TB1130

SERVICE INFO

LuK Part Nr. 233 0034 10 - 310/330mm TGU6

CNH / LINDNER / STEYR**

New design / Neues Design / Nouvelle conception / Nuevo diseño / Nuovo disegno

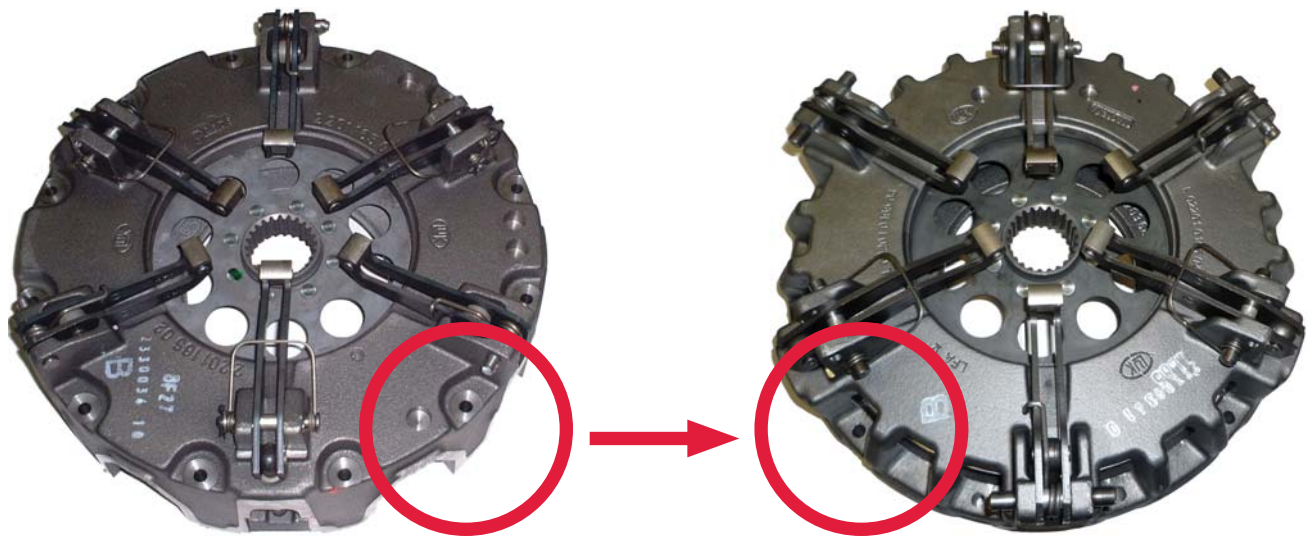
This new design utilises the latest clutch technology, using a vented housing for improved cooling and heat dispersal.

Fully interchangeable with existing clutches with no modifications required to vehicle or flywheel.

A new fixation bolt set **12 x M8 x 1.25 x 65mm** is supplied with new designs to accommodate the lower housing.
